# Sun SPARC Enterprise T5140 and T5240 Servers

## Product Notes

Part No.: Mfg. No.: E21413-04  
February 2012

# SPARC Enterprise T5140 and T5240 Product Notes

**FIGURE 1** Internal Cables for the Onboard SAS Controller Card (Four-Disk Capable SPARC Enterprise T5140 Servers)

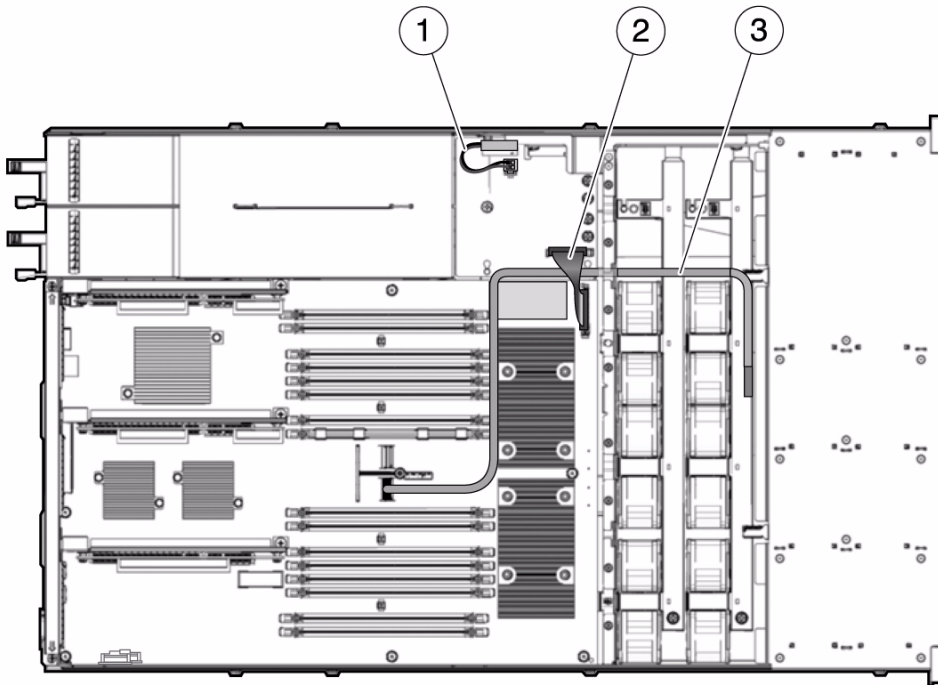
# Incorrect Data Cable Routing Diagram for Sun SPARC Enterprise T5140 Servers With 4-Disk Backplanes

The service manual data cable routing diagram for 4-disk capable backplanes is wrong. It shows the cable connected to SAS1. It should be connected to SAS0. This is the correct diagram:

**FIGURE 2** Internal Cables for Onboard SAS Controller Cards (Eight-Disk Capable SPARC Enterprise T5240 Servers)

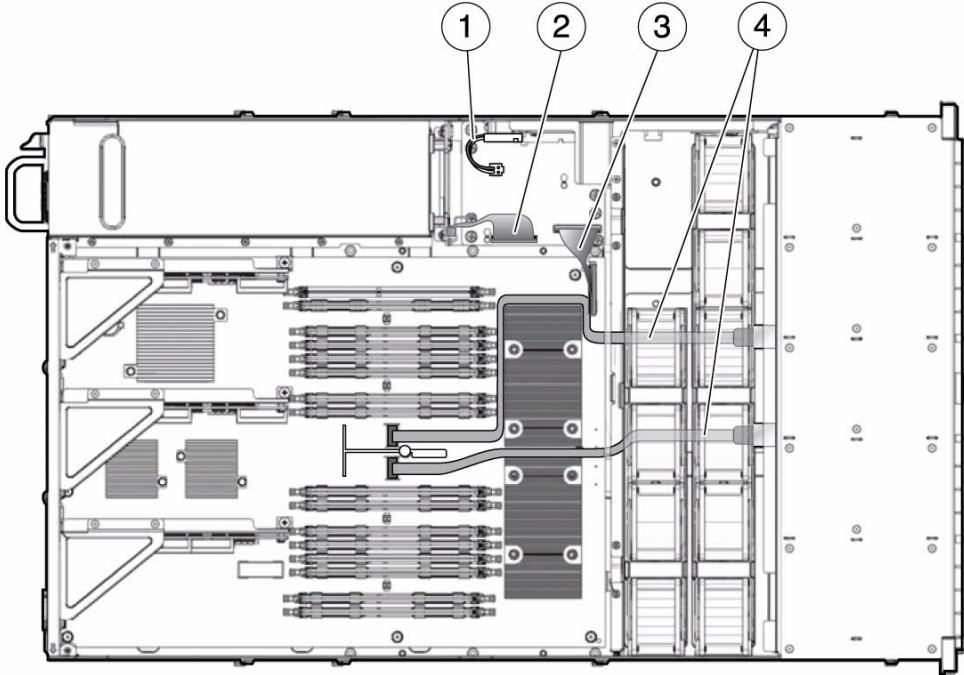
# Incorrect Data Cable Routing Diagram for Sun SPARC Enterprise T5240 Servers With 8-Disk Backplanes

The service manual data cable routing diagram for 8-disk capable backplanes in T5240 servers is wrong. It shows a single data cable. There should be two. This is the correct diagram:

**FIGURE 3** Internal Cables for the Onboard SAS Controller Card (Eight-Disk Capable SPARC Enterprise T5140 Servers)

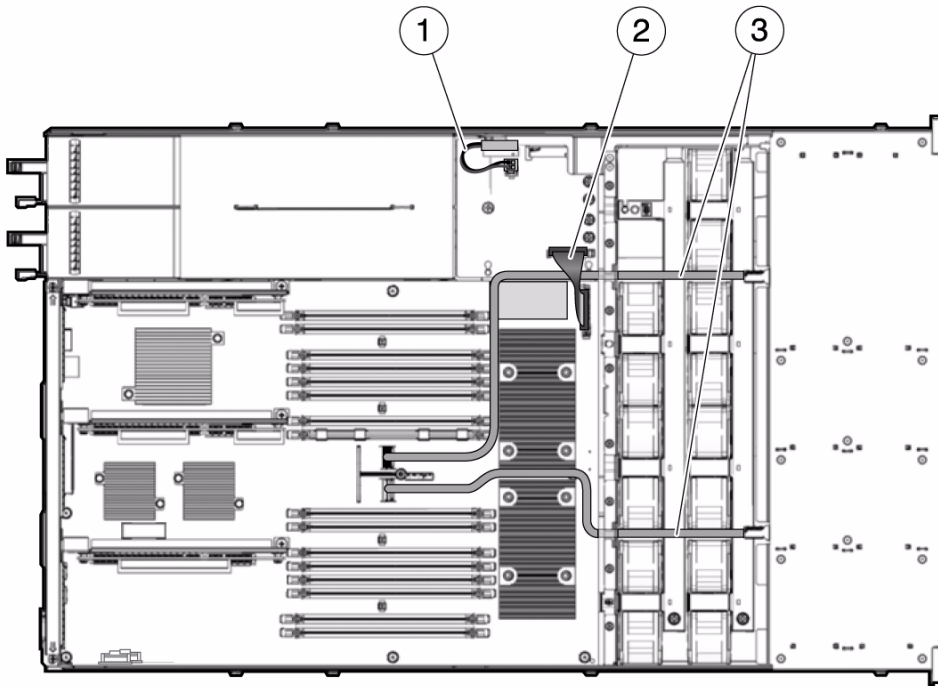
# Fan Module Missing in Data Cable Routing Diagram

The service manual cable routing diagram for 8-disk capable backplanes in T5140 servers is missing a fan module in the upper right corner. This is the correct diagram:

**FIGURE 4** HDD Data Cable Routing for SAS RAID Controller Card in Eight-Disk Capable SPARC Enterprise T5140 Servers

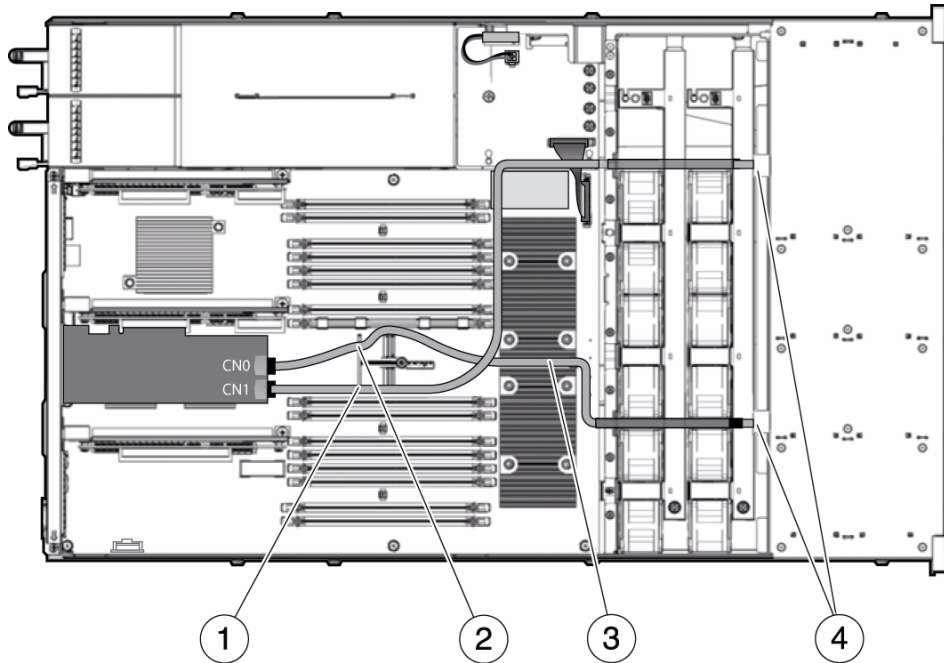
## Incorrect SAS RAID HBA Data Cable Routing Information for Systems With 8- or 16-Disk Capable Backplanes (CR 6776592)

Currently, the CN0 and CN1 port connections are the opposite of what they should be. The following list describes the correct SAS data cable connections and provides illustrations of the correct cable routing:

- CN0 <--> P2 (J0301)
- CN1 <--> P3 (J0302)
- [FIGURE 4](#) in this manual shows the correct cable routing information for eight-disk capable T5140 servers. Use it in place of the figure shown on page 194 of the Service Manual.
- [FIGURE 5](#) in this manual shows the correct cable routing information for eight- or sixteen-disk capable T5240 servers. Use it in place of the figure shown on page 207 of the Service Manual.

- Use [FIGURE 4](#) from this manual in place of Figure 7 in the HBA Installation Manual.
- Use [FIGURE 5](#) from this manual in place of Figure 11 in the HBA Installation Manual.
- For T5140 servers, change all CN0 and CN1 routing instructions associated with these figures so that the longer data cable connects CN0 to P2 (J0301) and the shorter data cable connects CN1 to P3 (J0302).
- For T5240 servers, change all CN0 and CN1 routing instructions associated with these figures so that one data cable connects CN0 to P2 (J0301) and the other data cable connects CN1 to P3 (J0302).
